Planning & Zoning Board

**MINUTES REGULAR MEETING
REYNOLDSBURG PLANNING & ZONING BOARD
February 22, 2024**

RE: Aurtec Designs LLC/Victor Nduaguba & Ugo Nwoke; 441 Waggoner Road: Major Site Plan Application

Below is the staff review of the above referenced Major Site Plan Application.

PROJECT NAME	WAGGONER ROAD	PROJ #	1495	DRAWN BY	UN
TITLE	Proposed Site Plan	DRAWING #	A005	DATE	05-26-2022

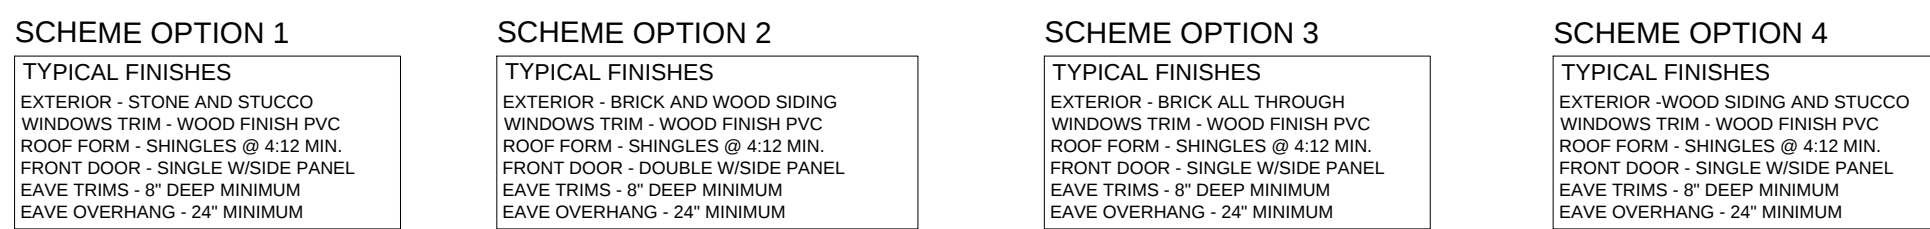
- e. *The location of all proposed walkways and pedestrian accesses within or to the site.*
 - i. The concrete walk proposed on the site plan states the concrete walk will be 5 feet wide and extends to Waggoner Road. The concrete walk on the utility plan and landscape plan state the concrete sidewalk will be 4 feet wide and does not extend to Waggoner Road.

- h. **Lot Coverage (Max.):** *The maximum lot coverage in the SR, Suburban Residential district is 60%.*
 - i. The lot coverage, including all impervious surface is not indicated on the data table. Please identify the square-footage of all impervious surfaces (private street, driveways, walks, home footprints) and indicate % coverage of the total site area. This is required for each proposed parcel within the proposed Major Site Plan.

- 1. Building 11 appears to not be measured from the closest point to the identified right-of-way on the site plan. Please measure the setback from the right front edge of the building to the right-of-way (if looking at the plans). It is unclear if the required 20 foot setback is met since the proposed private road curves upward toward the building.

1. A 5 foot sidewalk is shown, however the utility and landscape plan state the sidewalk to be 4 feet. The sidewalk measurement should be consistent throughout all plans.

- b. **Lot Coverage (Max.):** The maximum lot coverage in the SR district is 60%. The lot coverage, including all impervious surface is not indicated on the data table. Please identify the square-footage of all impervious surfaces (private street, driveways, walks, home footprints) and indicate % coverage of the total site area. **The Lot coverage data table is already shown on sheet A005**

- ii. *Setbacks: Minimum required setbacks are 20 ft. front, 5 ft. side, and 30 ft. rear.* Although the front setbacks vary, the proposed minimum setbacks shown are 21'-5" front, 5 ft. side, and 30 ft. rear. The front setbacks was measured from the front building face to what is labeled as the right-of-way for Fongod Court. **Typically with the proposed easement from the various lots to provide communal access for the private road, there is the option of calculating the set back from the middle of the road however we decided on the right of way to move the houses further back into the lot.**

5. Pavement composition shall meet the requirements as shown in the City's standard drawings.
6. A 4-foot wide sidewalk is shown along the north side of the proposed roadway. The minimum sidewalk width per the City's Standard Drawing R-9 is 5-feet. **This has been revised to 5 feet wide sidewalk as per A005**

- a. A ramp is shown entering the cul-de-sac with no receiving ramp. Please provide a receiving ramp or path for pedestrians to follow. **This has been revised. Please see sheet 005**

- b. A ramp is shown entering the roadway near the entrance with no receiving ramp. The walk may need to be extended closer to Waggoner Road and the connection to future pedestrian facilities along Waggoner Road coordinated with the City. **This has been revised. Please see sheet A005**

DRAWING #
A010

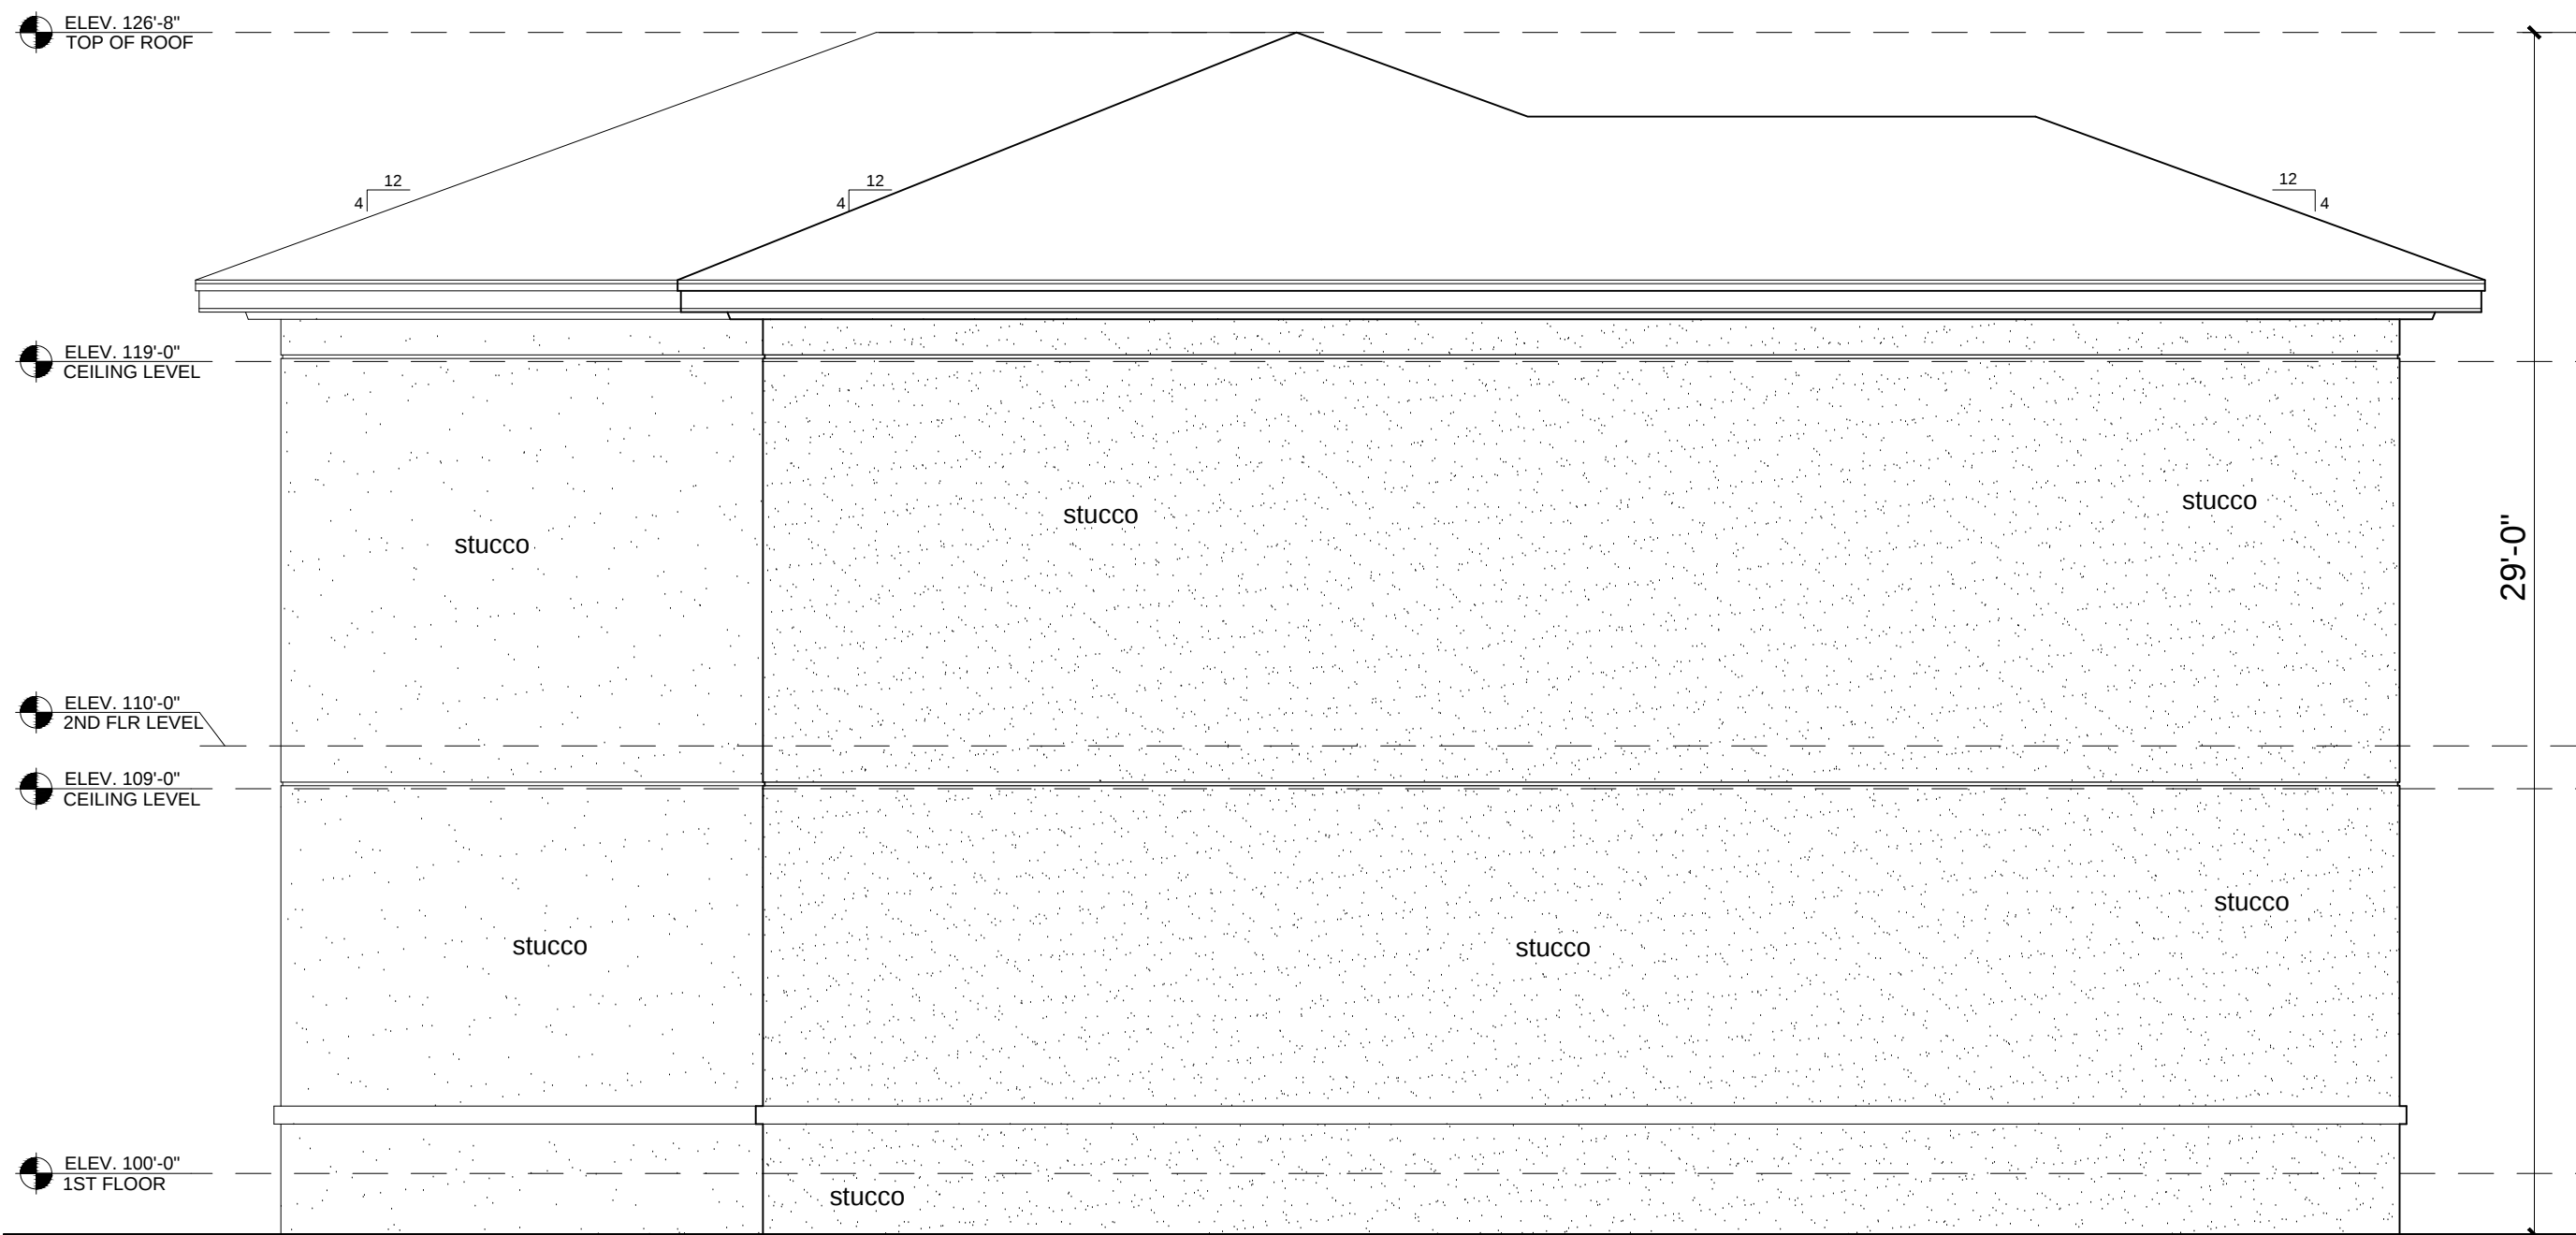
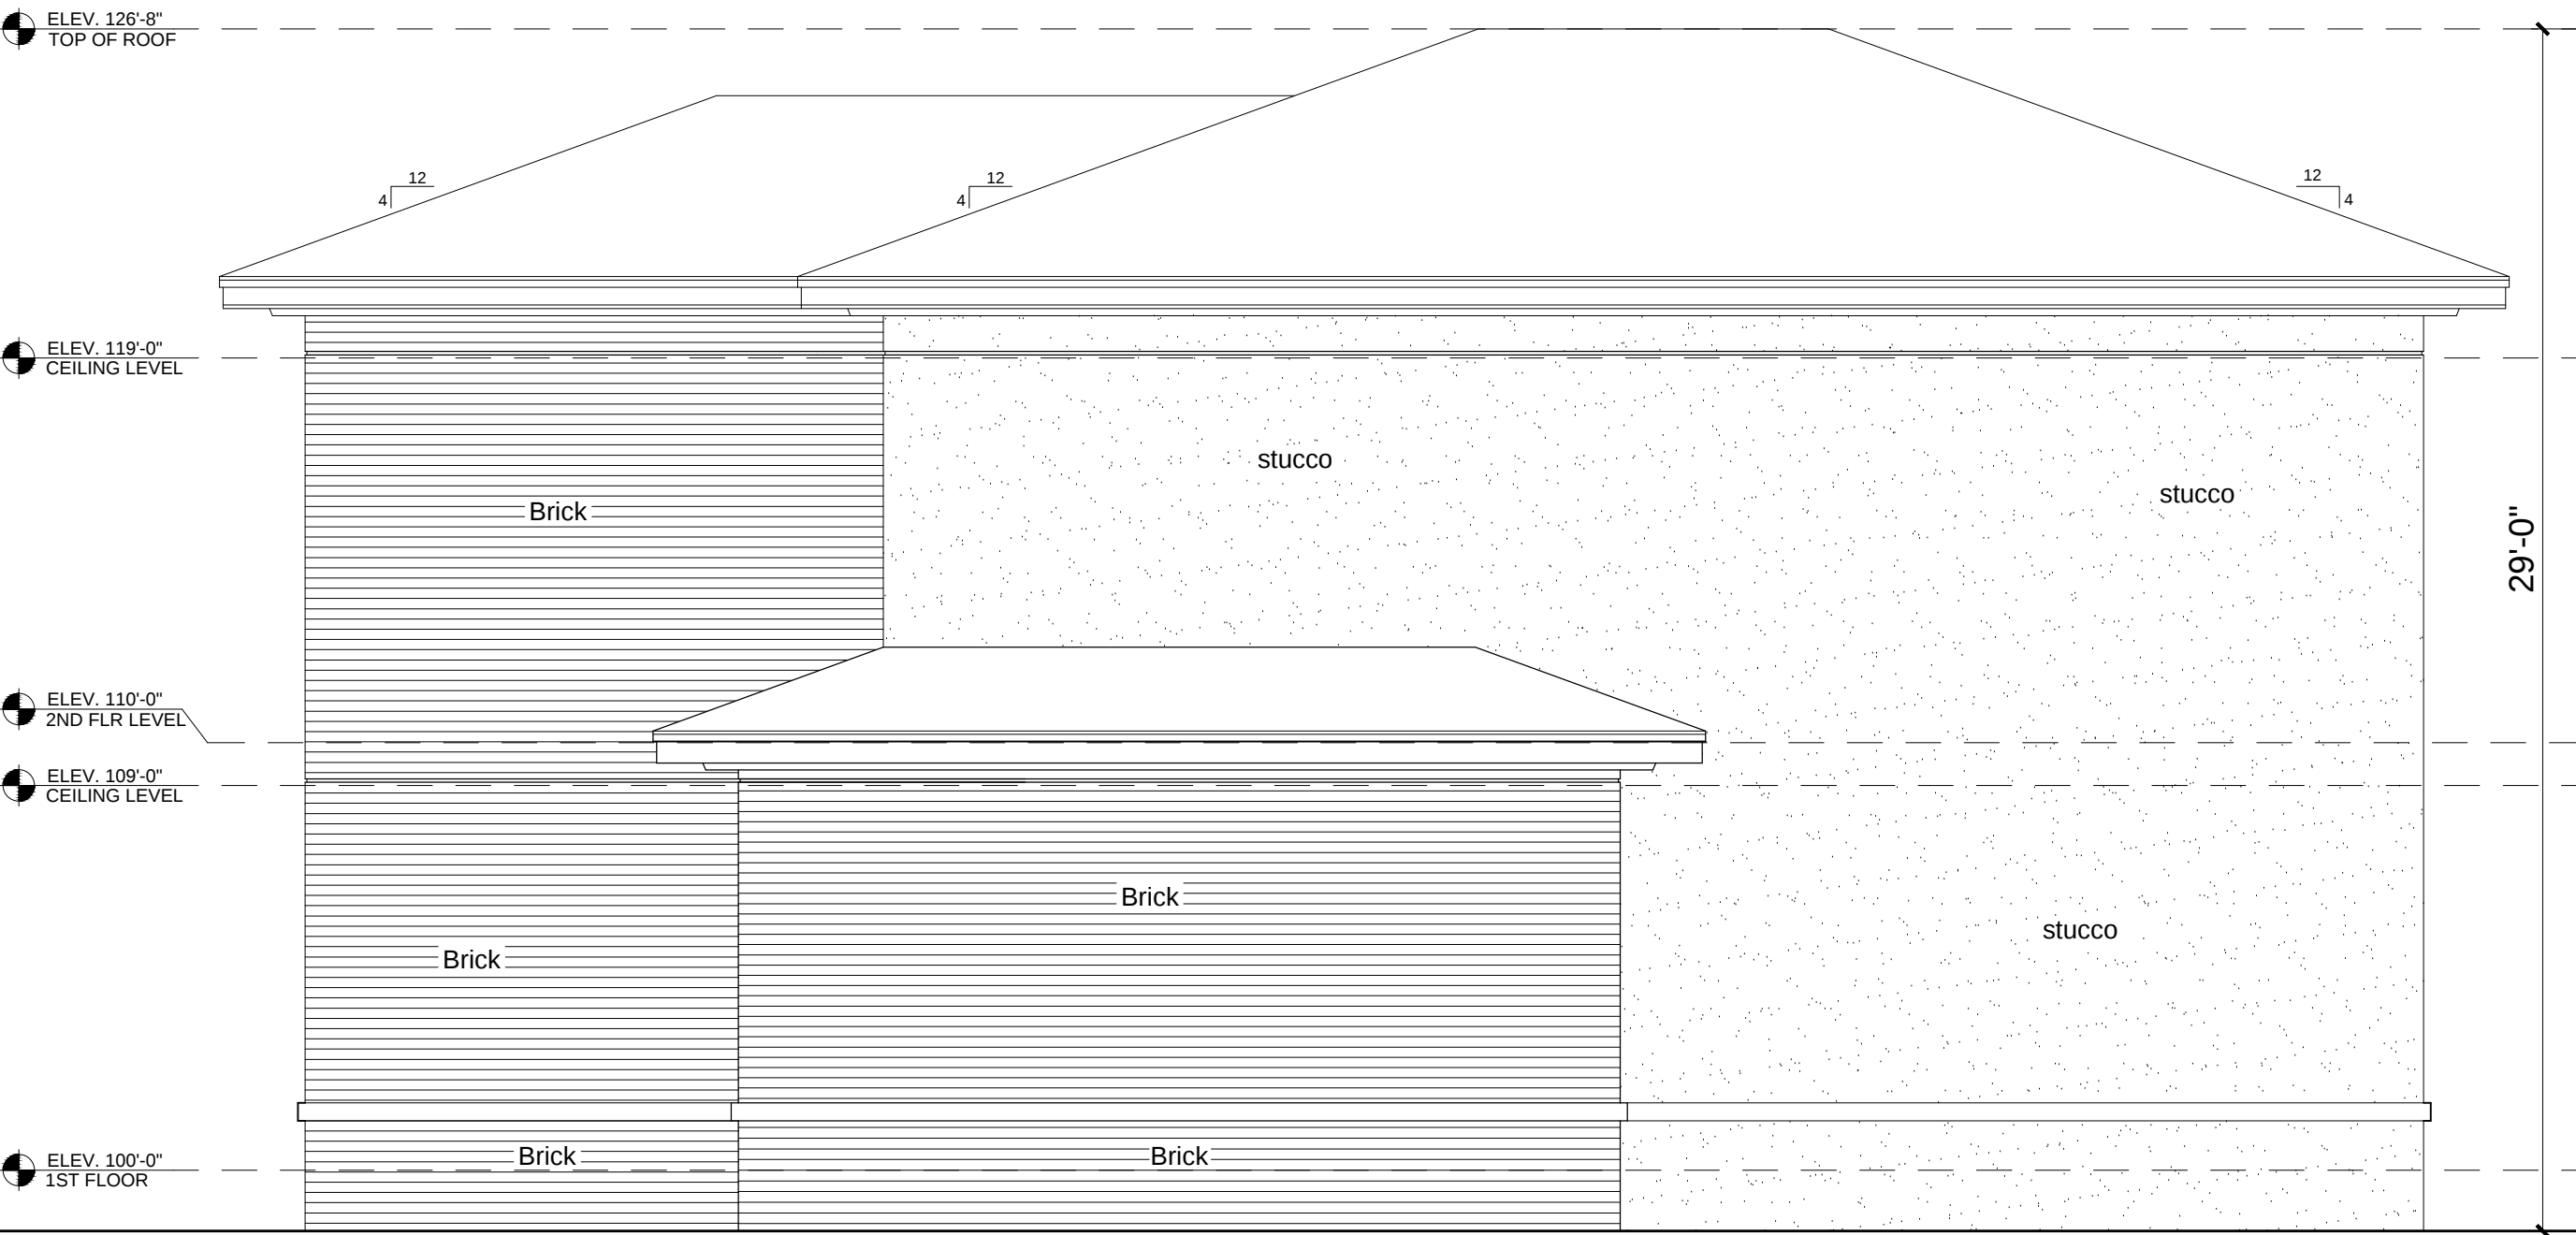
- i. The site plan states a maximum building height of 31 feet, but the elevations show a maximum building height of 29 feet. Building height should be indicated on the elevation drawings as measured from the midpoint of the roof.

- 1. Please provide the correct height, along with a consistent number for the building height throughout the plans where mentioned.

- d. **Height:** Building height is measured as the vertical distance measured from the average elevation of the proposed finished grade at the front of the building to "the midpoint of any pitched gable, hip or the upper portion of a gambrel roof." The maximum height of a building in the SR District 35 feet. The site plan indicates a maximum height of 31 feet. Building heights should be indicated on the elevation drawings as measured from the midpoint of the roof. **Please see sheets A010, A011. The proposed maximum height is currently 29'-0.**
